Access Compliance Report Public Rights-of-Way (Curb Ramps)

Main Street: YORBA_ST Cross Street: RAINIER_DR Location: NW

ADA ID: RPRK211006151539 Ramp Type: Type 7 - Directional 2 Initial Pass/Fail: Fail Overall Compliance: No Severity Score: 15

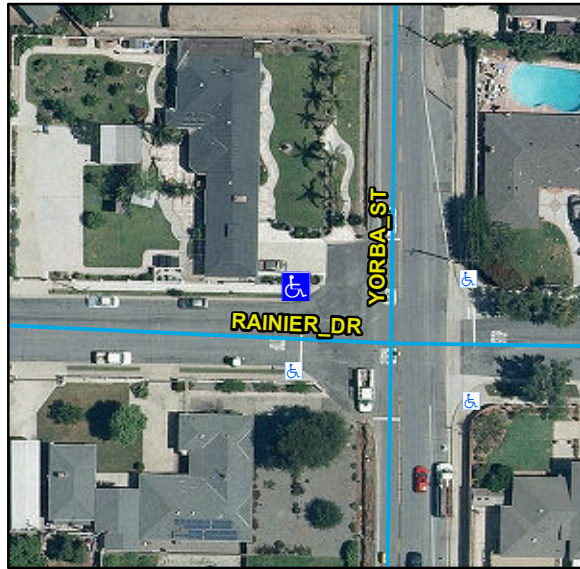
R204.3, R304.2.2, R302.7.2, STD 1115

Remove & Replace Entire Ramp. Grind Gutter Lip.
